**DETAILED REVIEW OF SELECTED ASPECTS OF  
TOTAL SYSTEM PERFORMANCE ASSESSMENT — 1995**

**Nuclear Regulatory Commission  
Contract NRC-02-93-005**

**Center for Nuclear Waste Regulatory Analyses  
San Antonio, Texas**

**August 1997  
(Revision)**

Figure 2-1. Effect of galvanic coupling on the waste package failure time for three values of areal mass loading, assuming no water infiltration ( $q_{inf}=0$  mm/yr) in the absence of ventilation and backfilling. Arrows denote failure times greater than 10,000 yr.

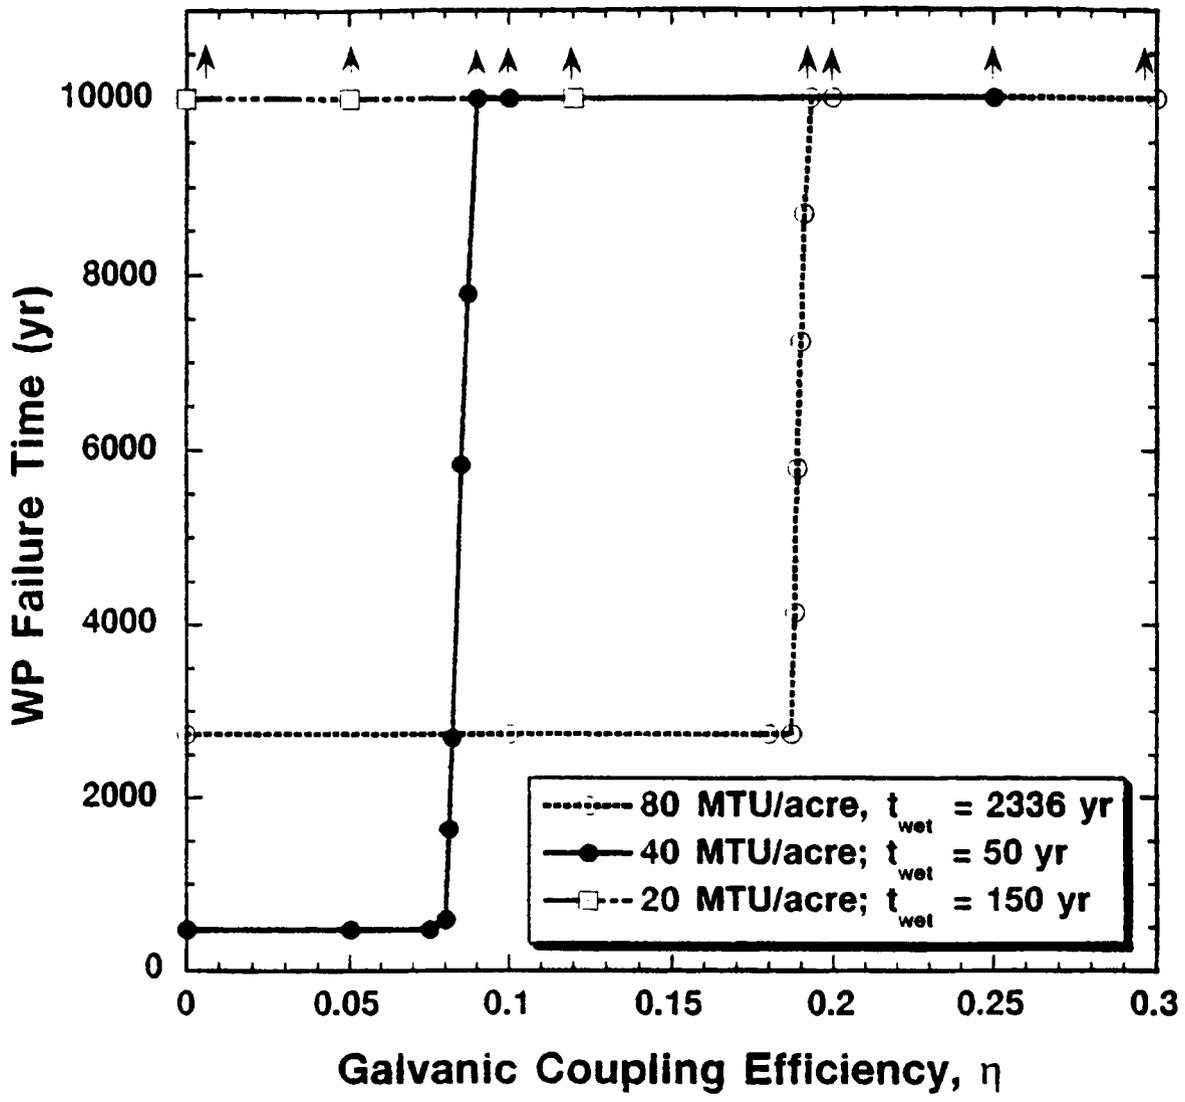
Figure 2-1 shows the calculated WP failure time as a function of the galvanic coupling efficiency ( $\eta$ ) for three values of the areal mass loading (AML), currently a repository design variable. The calculations correspond to the thermal model cases (Mohanty et al., 1996) in which no ventilation occurs during the initial 100-yr operations period and no backfill is emplaced after permanent closure. It is seen that at 80 MTU/acre, which is close to the value adopted in TSPA-95 for the high-thermal loading case,  $\eta$  has an important effect on the WP failure time which increases abruptly from 2,736 yr to more than 10,000 yr (the simulation time) for  $\eta$  values close to 0.2. A similar effect is observed at 40 MTU/acre where failure time increases from 472 yr to more than 10,000 yr for  $\eta$  values just above 0.08. On the contrary, at 20 MTU/acre, failure time is always greater than 10,000 yr regardless of the value of  $\eta$ . If galvanic coupling is completely ineffective ( $\eta = 0$ ), the shortest failure time occurs at the intermediate AML (40 MTU/acre). The wetting time is also the shortest at the intermediate AML, but the differences in failure times are only explainable by the effect of temperature on the initiation of localized corrosion. The wetting times, corresponding to a critical value of RH equal to 65 percent, are 153, 50, and 2,336 yr for 20, 40, and 80 MTU/acre.

Although penetration by localized corrosion of the outer container occurs in a few hundred years, only slow passive dissolution of the inner Alloy 825 container takes place subsequently for 20 MTU/acre because  $E_{corr}$  is lower than the critical potential for localized corrosion at the relatively low temperatures encountered at this low AML. In this case, the inner container fails just after 10,000 yr. In summary, the critical potential above which localized corrosion occurs increases with a decrease in temperature so the likelihood of localized corrosion for a given chemical environment decreases with a decrease in AML. At high AML, the WP remains dry for a long period and the container life is long. These two competing factors lead to a minimum container life at an intermediate AML. If efficient galvanic coupling occurs, container life can be greater than 10,000 yr, independent of the AML value.

Figure 2-2. Waste package failure time as a function of thermal loading, ventilation, and galvanic coupling, assuming no water infiltration ( $q_{inf}=0$  mm/yr) in the presence of ventilation and backfilling after closure

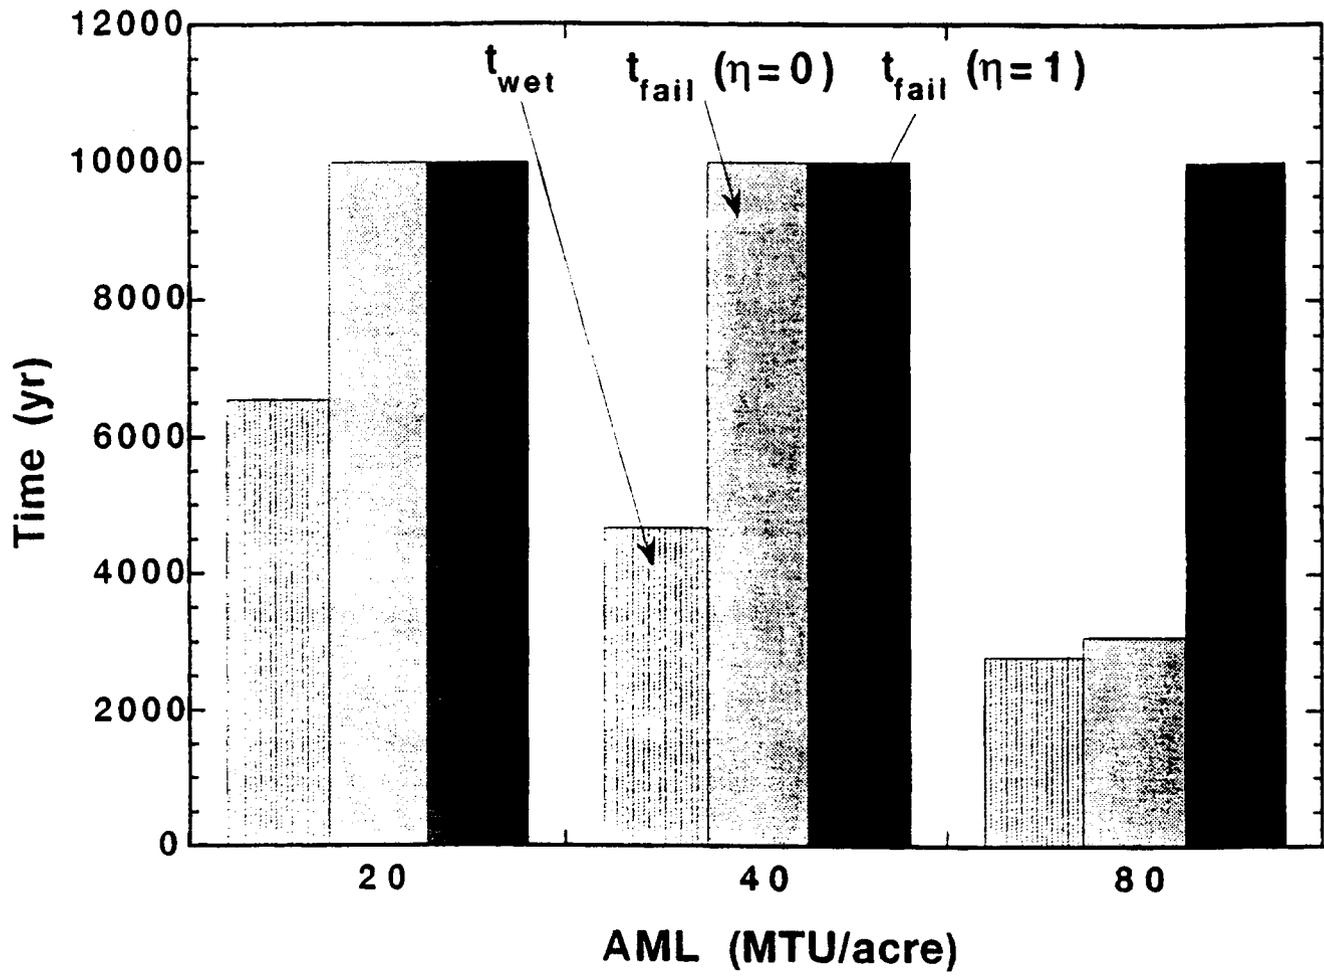
With ventilation during the operation period and backfill material emplaced upon closure, the calculated failure time is longer than 10,000 yr at low values of AML, as shown in figure 2-2, regardless of the effect of galvanic coupling. At 80 MTU/acre, the WP life increases from 2,636 yr to more than 10,000 yr as a result of effective galvanic coupling ( $\eta = 1$ ). The wetting times decrease with increasing AML in the presence of ventilation and backfilling, as presented in figure 2-2.

The limitations of the simplified approach used in the modeling of galvanic coupling should be noted. The beneficial effect of galvanic coupling could be limited to times significantly shorter than 10,000 yr as a result of the enhanced galvanic corrosion of the outer steel overpack which may lead to its premature consumption. In addition, a more fundamental approach to the modeling of galvanic coupling in terms of electrochemical kinetics theory can provide adequate justification for the selection of an appropriate range of  $\eta$  values. The value of  $\eta$  can be significantly affected by the resistance of the electrolytic path to the flow of current, the presence of deposited corrosion products acting as high-impedance surface contacts between the metallic barriers, and the size and distribution of pits penetrating the outer container.

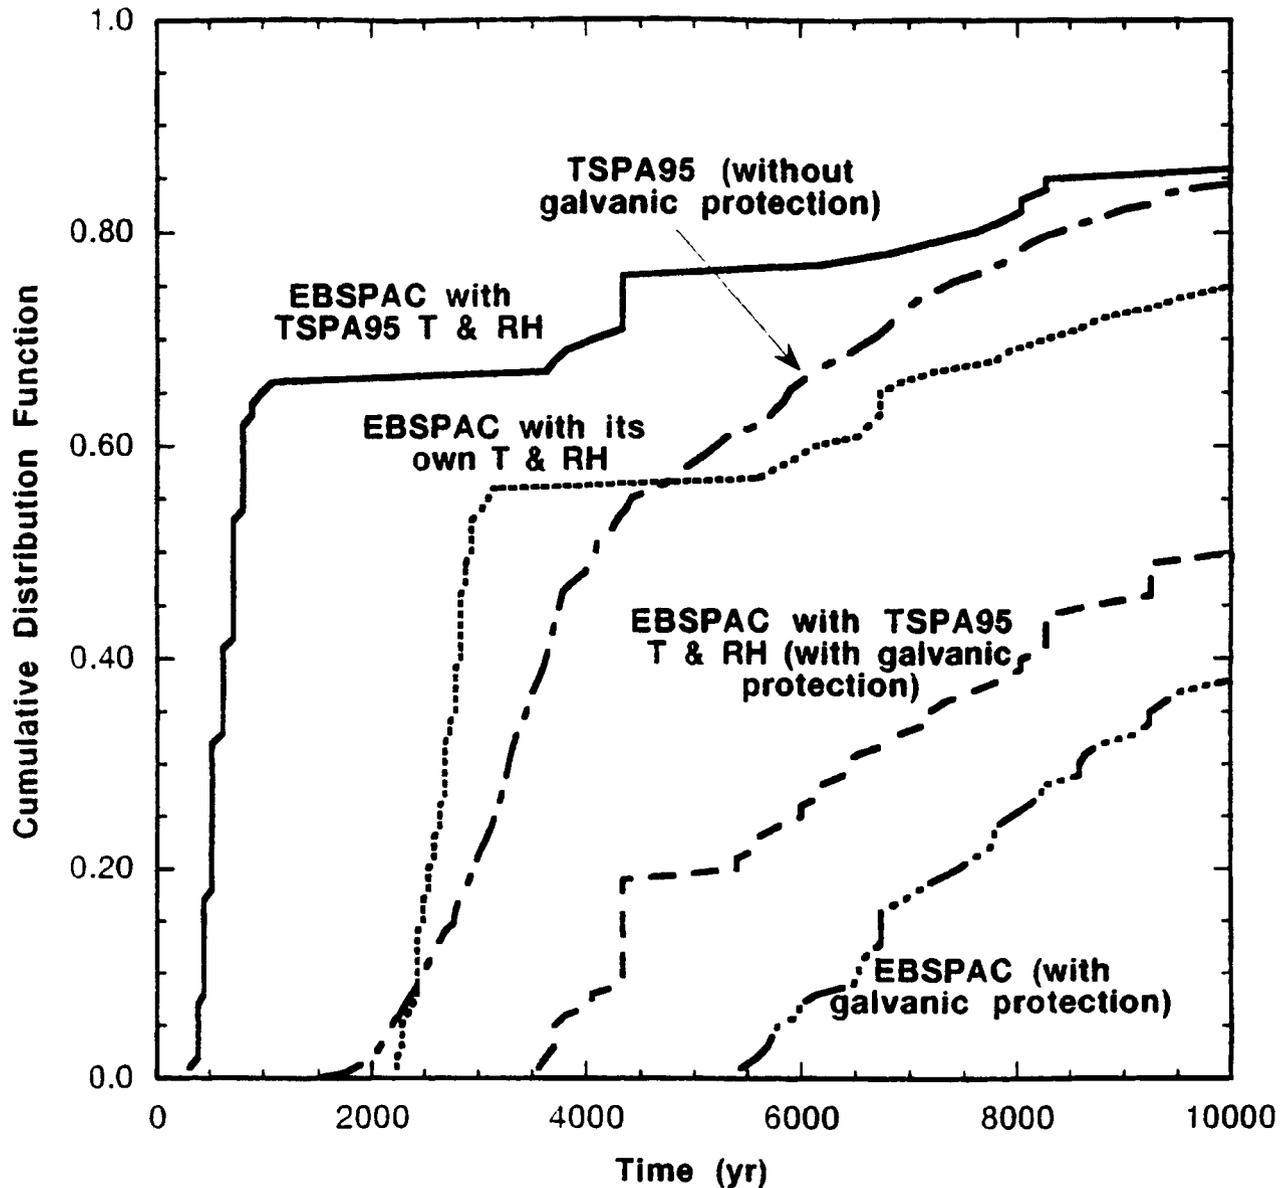
The cumulative distribution of lifetimes with and without galvanic coupling, in the absence of ventilation and backfilling after closure, is presented in figure 2-3 for a value of AML equal to 80 MTU/acre. The failure distribution curves from TSPA-95 are compared with those from EBSPAC Version 1.0β. In the absence of galvanic coupling, the percentage failure after 10,000 yr is greater for TSPA-95 calculations. However, a significant percentage of WP failures takes place between 2,000 and 3,000 yr in the EBSPAC Version 1.0β calculation compared to a more gradual increase in the percentage failure with time for TSPA-95. As a consequence, the median WP failure time is about 3,000 yr shorter in the EBSPAC Version 1.0β calculations. When effective galvanic coupling occurs, the WP percentage failure at 10,000 yr is significantly decreased, and the first failure is delayed by nearly 3,000 yr in the curve representing the EBSPAC Version 1.0β results.

A significant difference was noticed when temperature and RH estimates used in EBSPAC Version 1.0β were compared with those given in TSPA-95 (Baca and Brient, 1996). If temperature and RH values in TSPA-95 are used as input to EBSPAC calculations, a significant difference in the WP failure time distribution is noticed. The results shown in figure 2-3 reveal that the WP lifetime after 10,000 yr is similar to that calculated in TSPA-95. However, the percentage of WP failures at shorter times remains significantly higher than that predicted by the DOE. It is also shown that the percentage of WP failure when galvanic protection occurs is greater using TSPA-95 temperature and RH values in the EBSPAC Version 1.0β calculations. Preliminary calculations were conducted using a critical RH uniformly distributed between 35 to 55 percent, instead of the 55 to 75 percent used in most simulations. The median WP failure time was reduced from approximately 2,800 yr to about 1,000 yr, mainly as a result of the decrease in the wetting time. These results indicate that temperature and RH calculations, as well as the value of the critical RH, should be realistically and accurately estimated because of their important effect on the rate of WP failure.
